Proposed

Modified Indirect Cooling system (Conversion from direct to Indirect Cooling system)

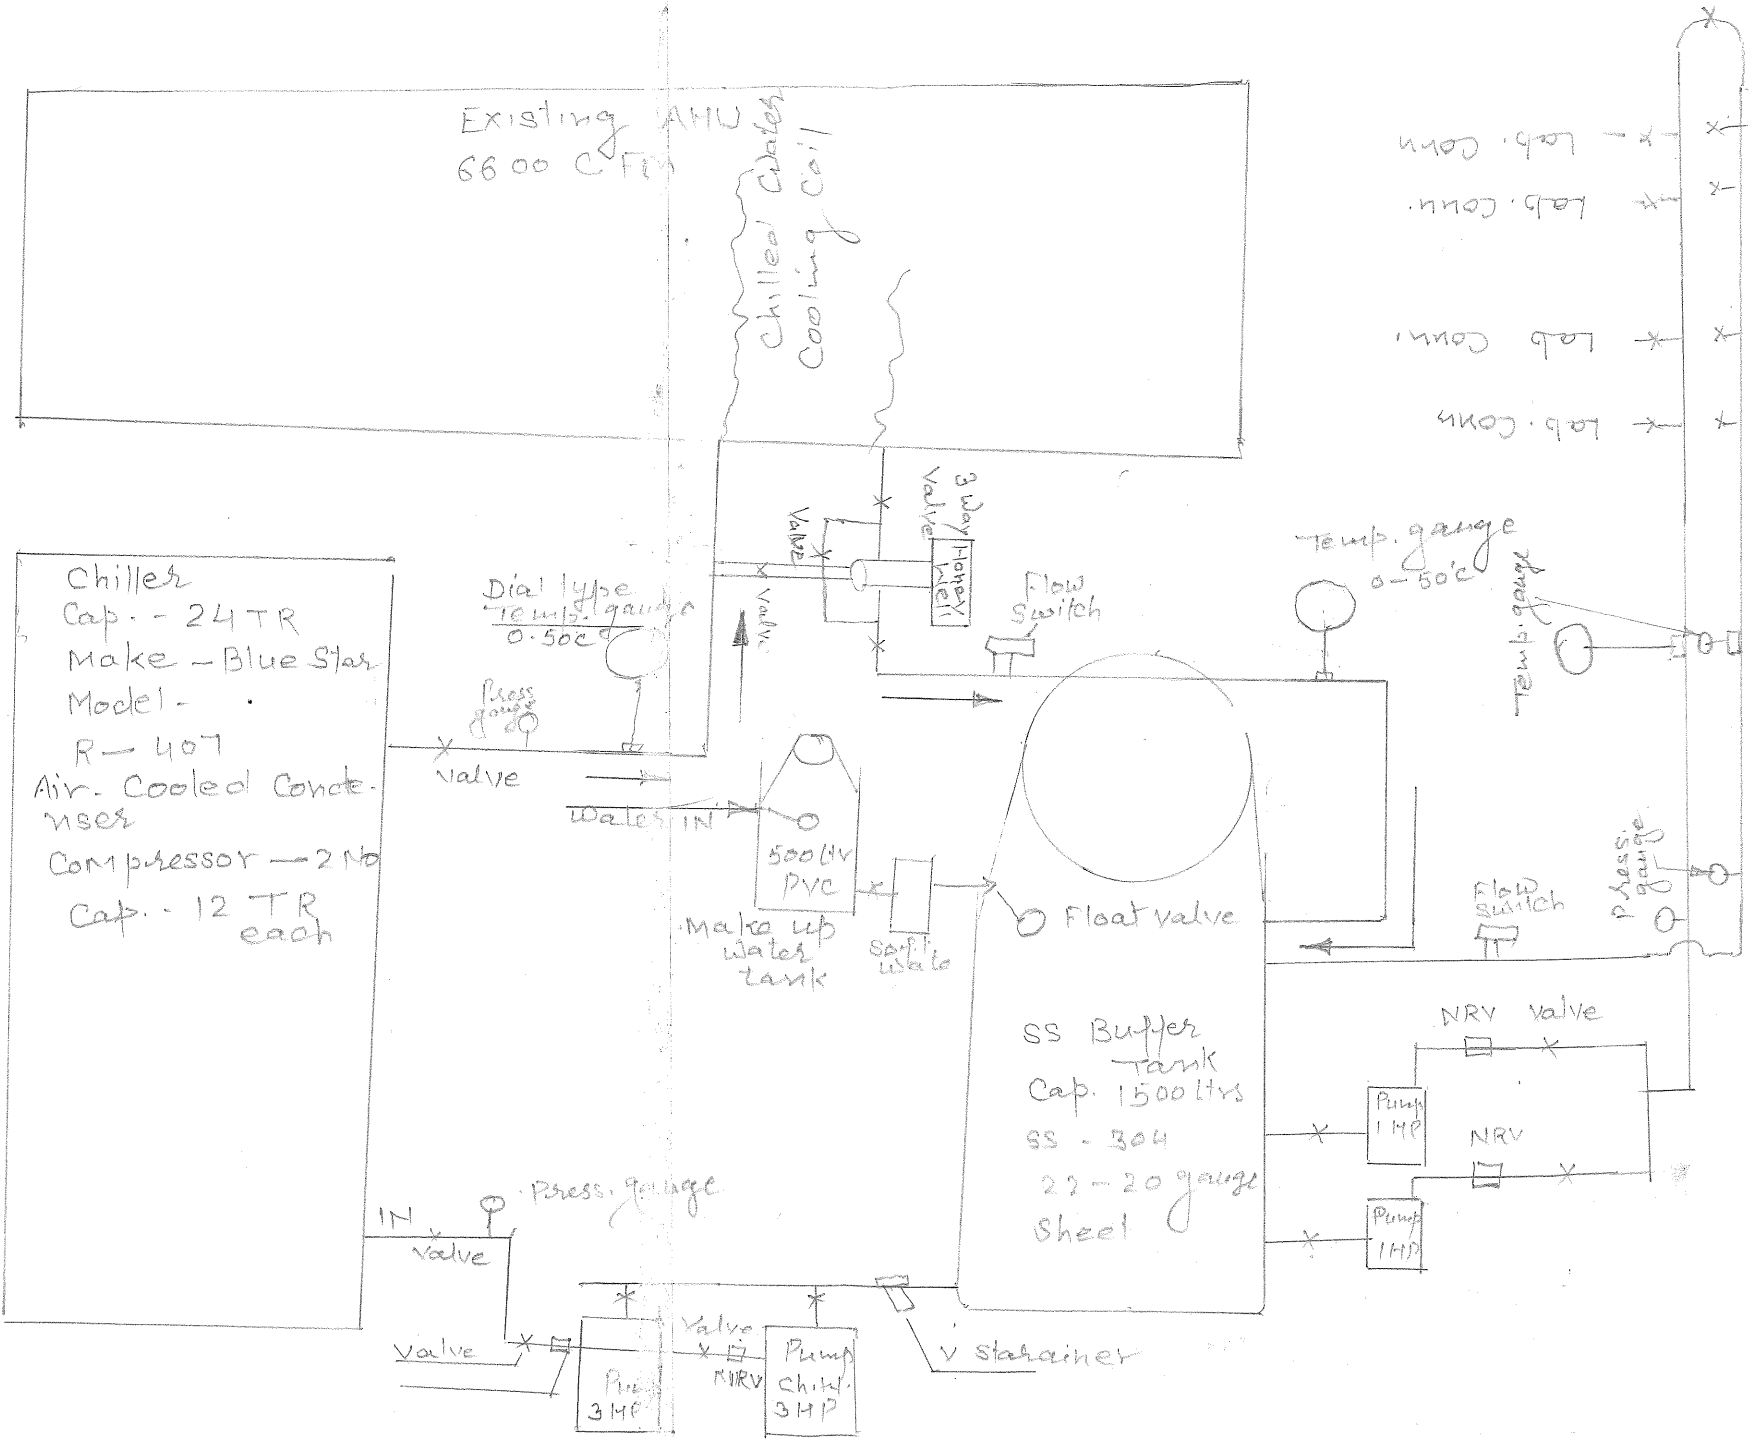
In proposed scheme, following is envisaged:

- (a) Remove outdoor (direct cooling) with 24TR (already at site) Chiller.
- (b) Remove all frusted Chilled water Cooling Coil
- (c) From 24TR Chiller MS line shall be laid upto existing AHU to feed Chilled water.
- (d) From 24TR Chiller, SS Piping shall be laid to feed chill water to Lab equipments.
- (e) In the scheme, make up tank, Temp gauge, Flow switch, 3 way valve, strainer have been considered.
- (f) Two 3HP pump shall be ~~not~~ installed to pump chill water.
